FINAL RECOMMENDATION OF THE EAST DESIGN REVIEW BOARD

Project Number: 3012797

Address: 802 Seneca Street

Date of Meeting: Wednesday, March 07, 2012

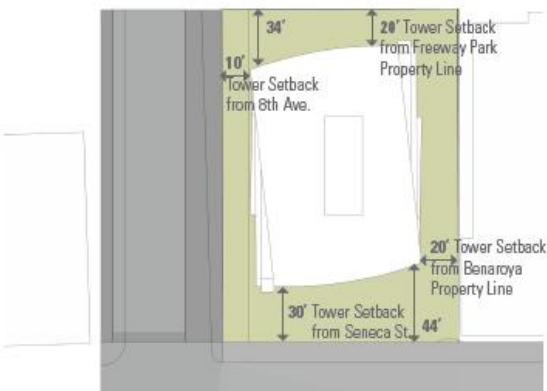
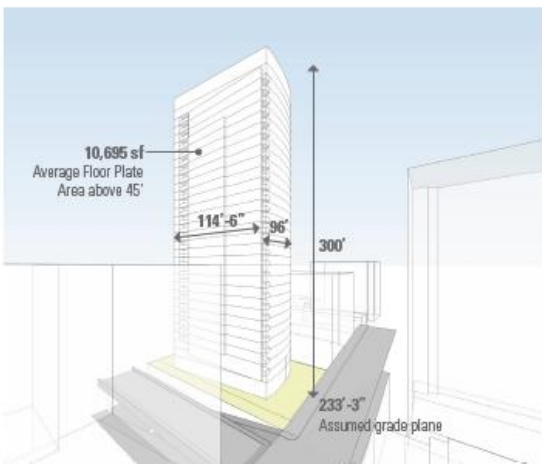
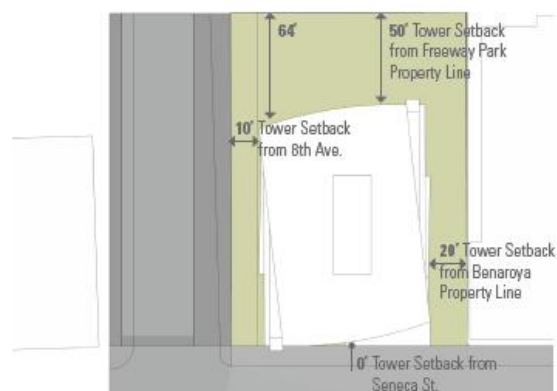
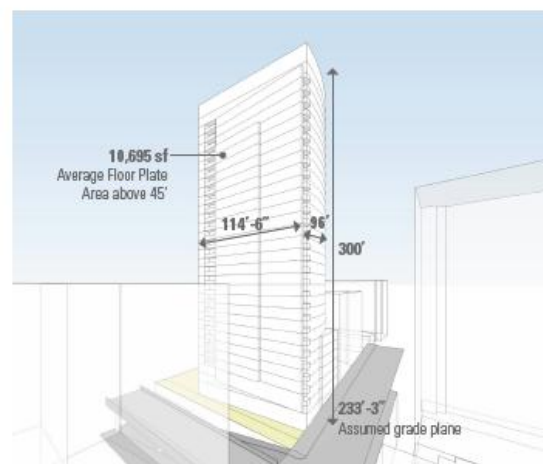
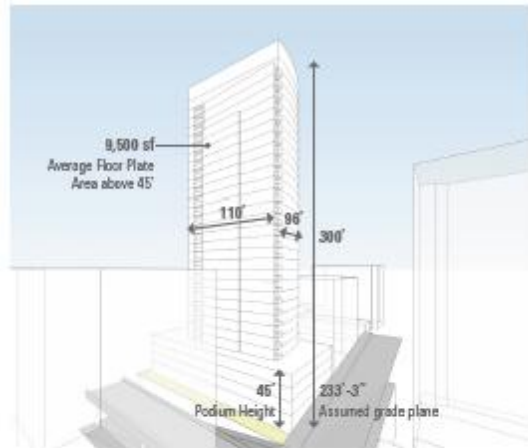
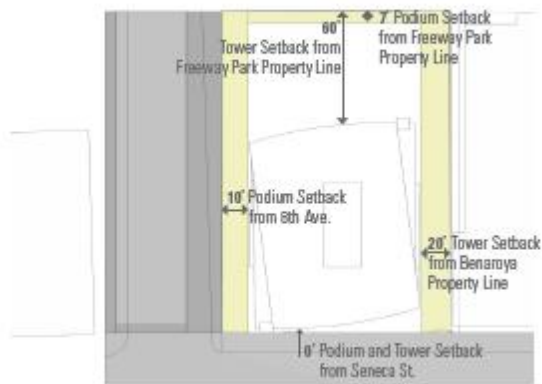
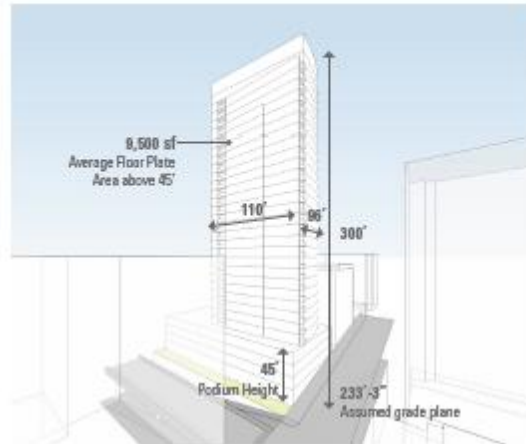
- Alternative C is better because the street wall is a better response to nearby urban context, and the podium could offer an opportunity to design a street wall in scale with nearby context. The setback and open space alternatives are more suburban in nature and not appropriate for this site. The stepped plazas with planter walls separating sidewalk from plaza could lead to the plazas feeling proprietary rather than public.

At the Early Design Guidance Meeting, the Board discussed the context of the nearby area as described more in response to Guideline C-1. The Board agreed that some version of Alternatives C or D may be better, since it allows for a strong street wall, a building base that responds to nearby First Hill neighborhood scale, and an upper tower that responds to nearby Downtown scale.
